Subject: Edison Mission Energy Sun Valley Energy Project

Thank you for making time for the site visit to the Edison Mission Energy Sun Valley Energy Project on October 19. Per our discussion in the field, we have clarified the project description, updated the map and provided detailed maps at a scale of 1 inch equals 100 feet showing the location of the project features in relation to the drainage features identified in the immediate vicinity. We have also included a description of the process that the CEC uses to ensure compliance with avoidance requirements for sensitive features.

MGLACIERISACGISISUNVALLEY_CCEPIMXDSIWETLANDS.MXD FIG 2 DRAINAGE FEATURES.PDF 11/15/2007 10 30:45

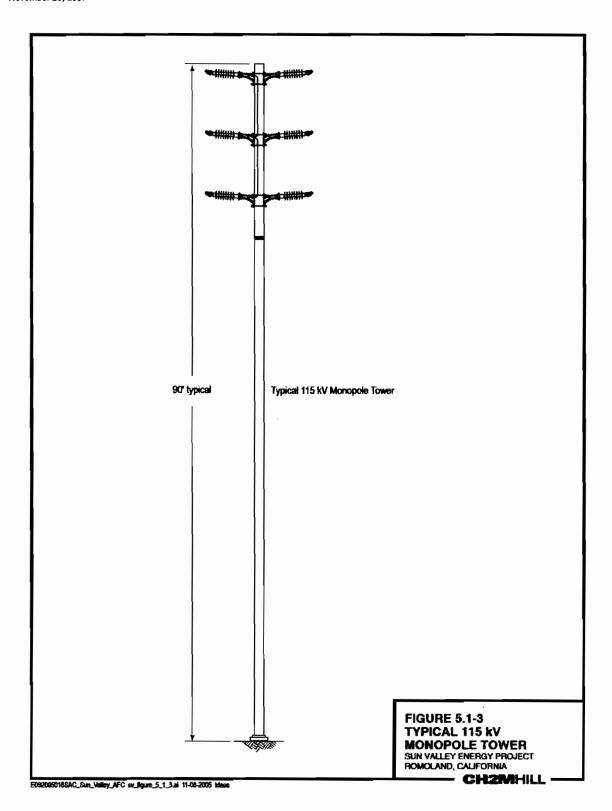
Changes to the figures include the following:

- The drainage ditch on the north side of Mathews Road is shown on the maps.
- The detention basin on the south side of the substation and the areas previously mapped as Roadside Drainage A and Roadside Drainage B are no longer present and have been removed from the maps.
- The remaining drainages have been relabeled for easier identification Drainage Swale
 A is now Drainage A and what was previously labeled as Drainage A is now Drainage
 D. The ditch on the north side of Matthews Road is Drainage E.

The other linear features shown on Figure 2 are underground pipelines that will include digging a trench and filling over the pipeline. All soil disturbances will be located within the existing disturbed areas of the roads. Per your request, a more detailed description of typical pipeline construction process in included below.
